STATE OF NORTH CAROLINA
DEPARTMENT OF TRANSPORTATION

Subject: **Information to comply with Section 401 conditions** for US 401 widening from SR 2044 (Ligon Mill Rd) to north of SR 2226 (Jonesville Rd), Wake County, Federal Aid No. STP-401(4), State Project No. 81403001, WBS 34506.1.1, Division 5, TIP R-2814 A.

Reference: Section 404 Individual Permit, issued July 14, 2009, USACE Action ID 2008-01316
Section 401 Individual Water Quality Certification, Isolated Wetlands Permit and Neuse Riparian Buffer Authorization issued June 16, 2009, NCDENR-DWQ Water Quality Certification Project No. 20090104 ver.1

Dry Retention Pond Design Revised 8/20/10

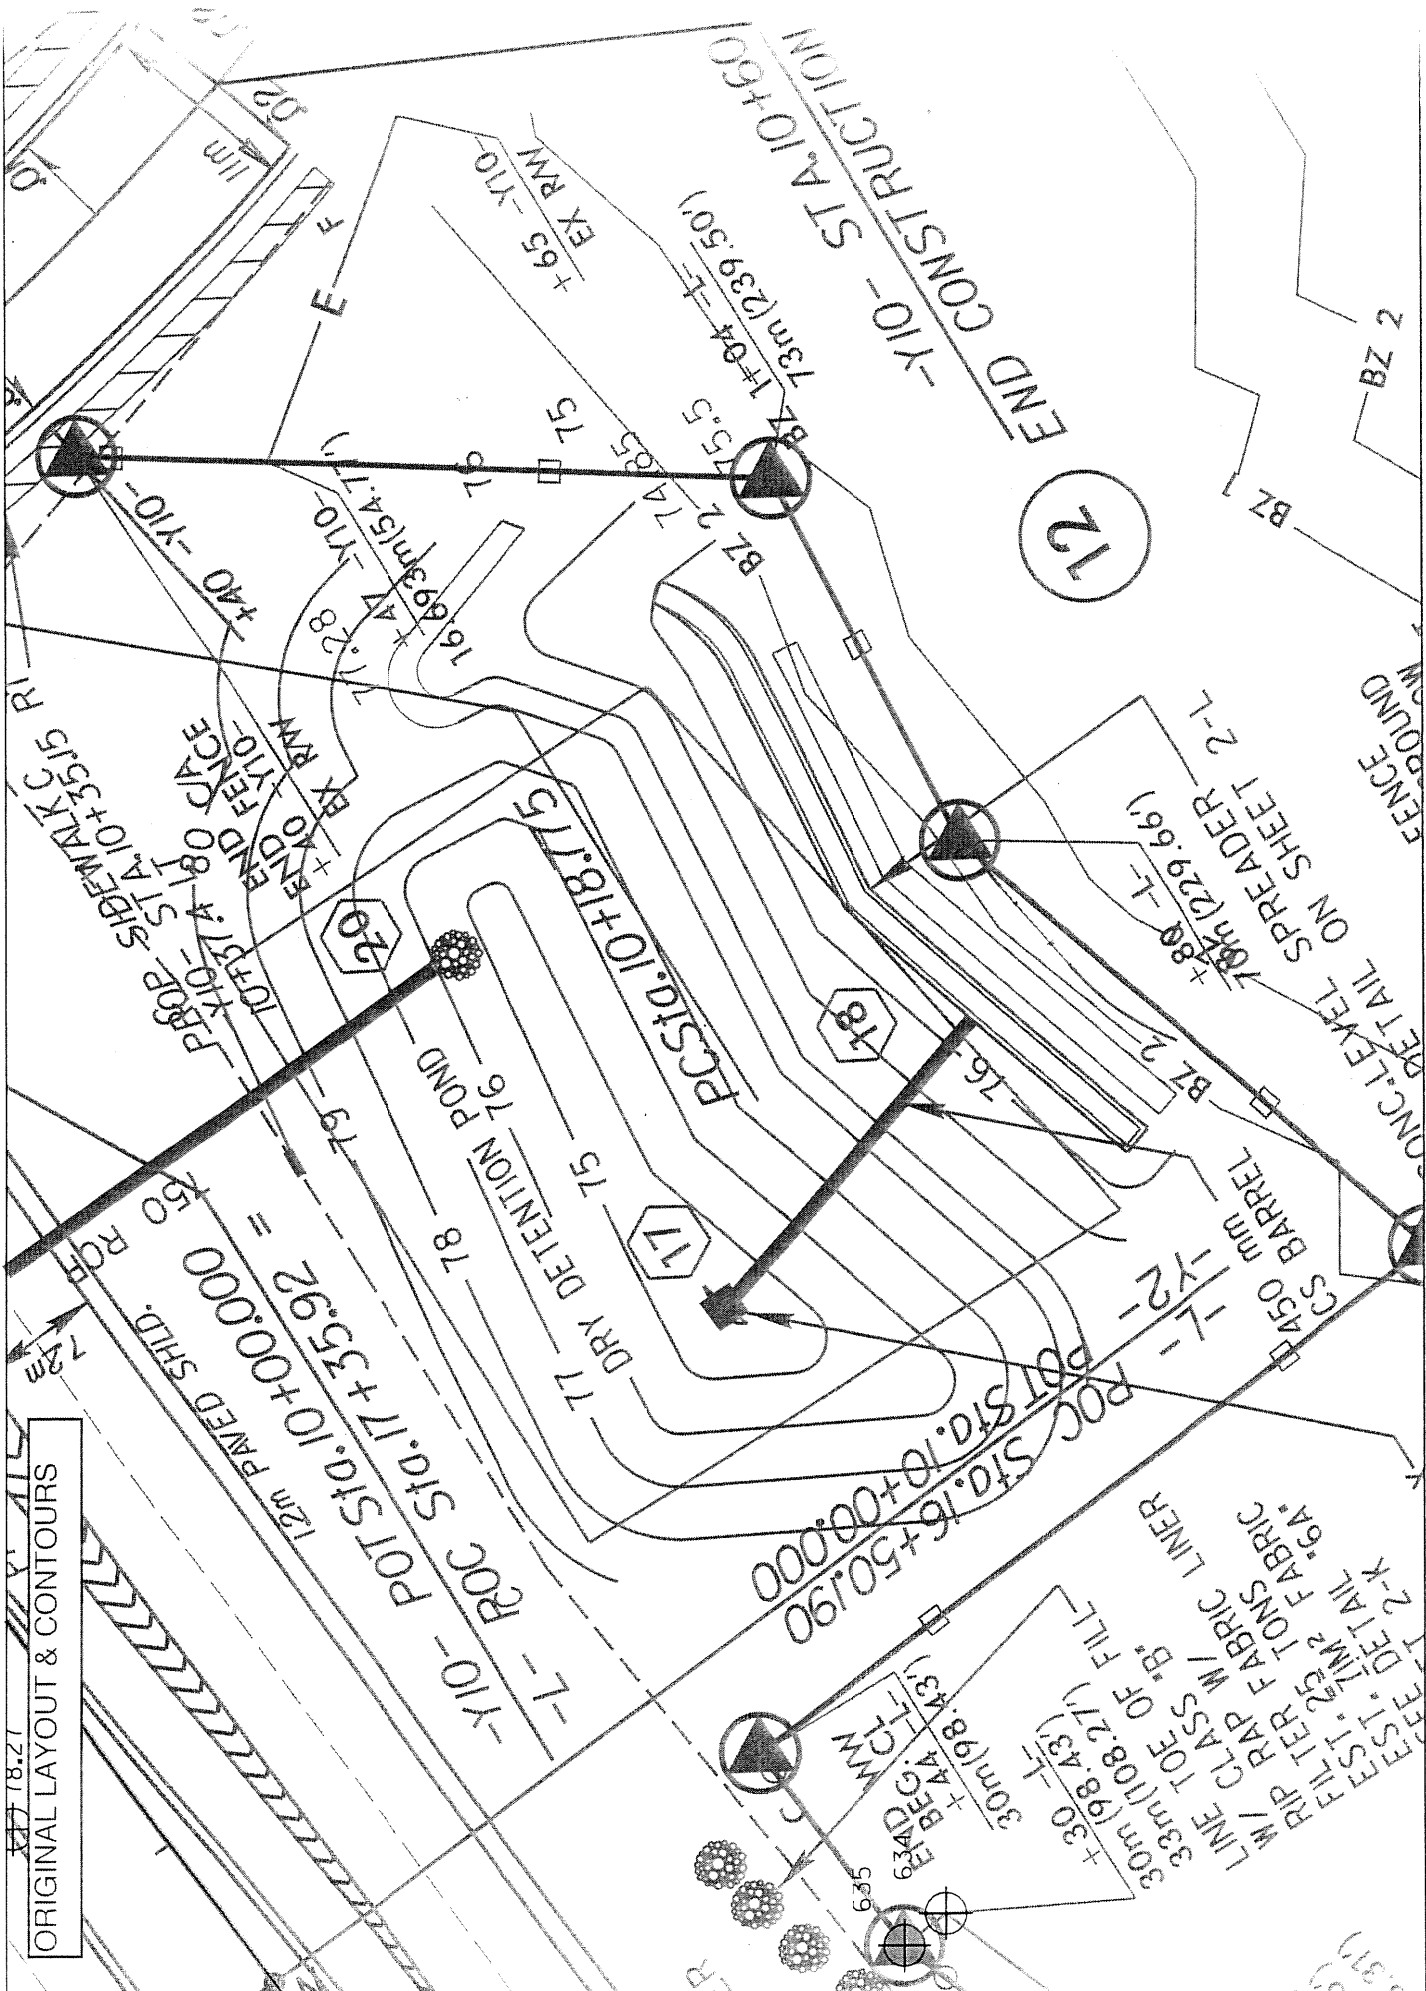
Due to a conflict with an existing sanitary sewer main, the dry detention pond at Sta. 16+80 +/- Rt was redesigned. The layout for the dry detention pond can be found on plan sheet 6 and the detail drawings can be found on plan sheet 2-L. The detention pond is also shown on buffer drawing 6.

There are two sewer manholes in conflict with the concrete level spreader located at the base of the detention pond outfall. We explored the option of extending the dry detention pond away from existing US 401 and towards the stream buffer to the southeast. We found that this could not be done without additional buffer impacts. Additionally, this would place the manholes within the limits of the detention pond and would conflict with grading activities necessary for pond construction.

The best alternative is to relocate the concrete level spreader towards US 401 and away from the stream buffer. This shift will reduce the width of the basin. This change in width has prompted the need to alter some of the plan contours of the basin in order to 1) Maintain basin capacity 2) Maintain plan elevations for bottom of basin and concrete spreader. Basin capacity or volume is critical to

- 1) The side slopes on the interior of the basin have been modified to 2:1 from the plan 3:1 depicted on plan sheet 2-L. All other dimensions shown on the basin typical section will be maintained. We feel that the 2:1 slopes will provide adequate stability within the basin.
- 2) In order to maintain plan volume within the basin, the south west side of the basin will be extended. Based on our design calculations, the revised volume in the pond will be slightly increased from the volume shown in the plans.
- 3) We propose installing PSRM at the outfall of the level spreader. We will cover all areas that are disturbed between the spreader and the stream buffer. This will ensure long term stability. We also propose replacing the existing soil in the area with topsoil that will promote ground cover.

PROJECT REFERENCE NO.	R-2814A	SHEET NO.	5
ROADWAY DESIGN ENGINEER		HYDRAULICS ENGINEER

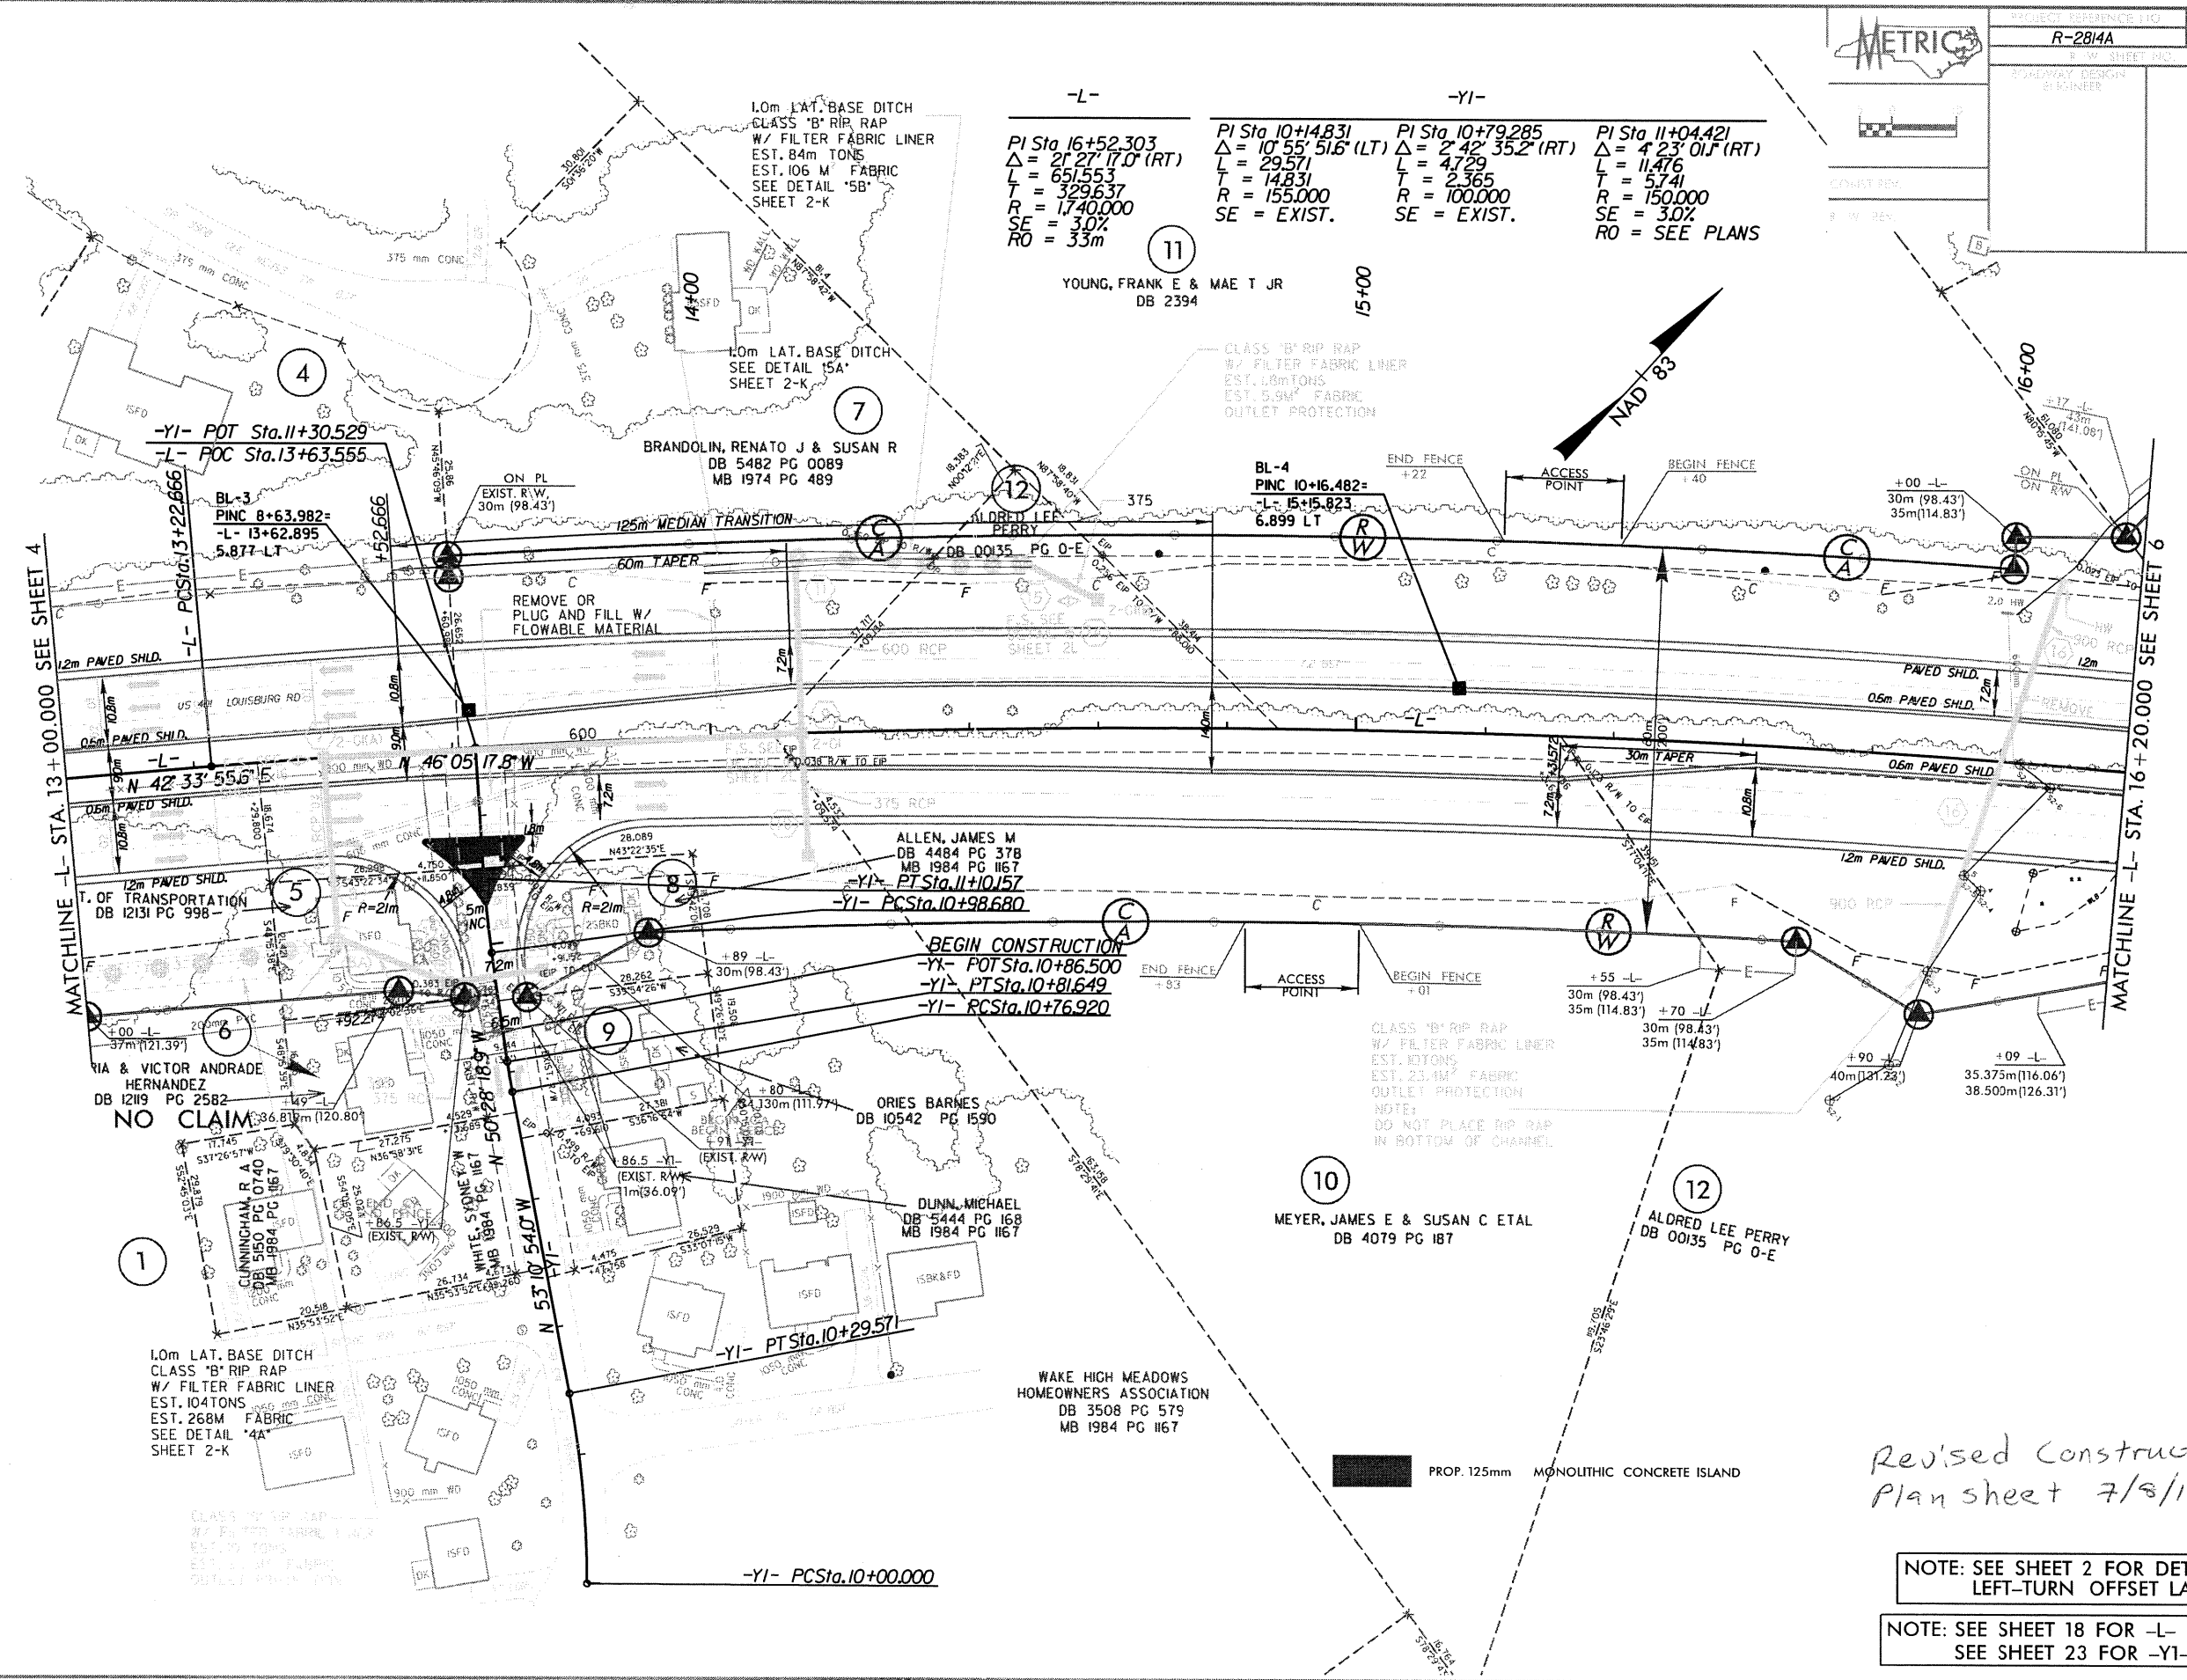
Issue: Stream permit drawings 8 and 9 depict a jurisdictional stream at the outlet of a 600 mm pipe structure at 15+90 Rt. However, a review of construction plan sheet 5 does not depict any stream or channel feature at this location.

Response: Revised construction plan 5 reflects the jurisdictional stream depicted on stream permit drawings 8 and 9.
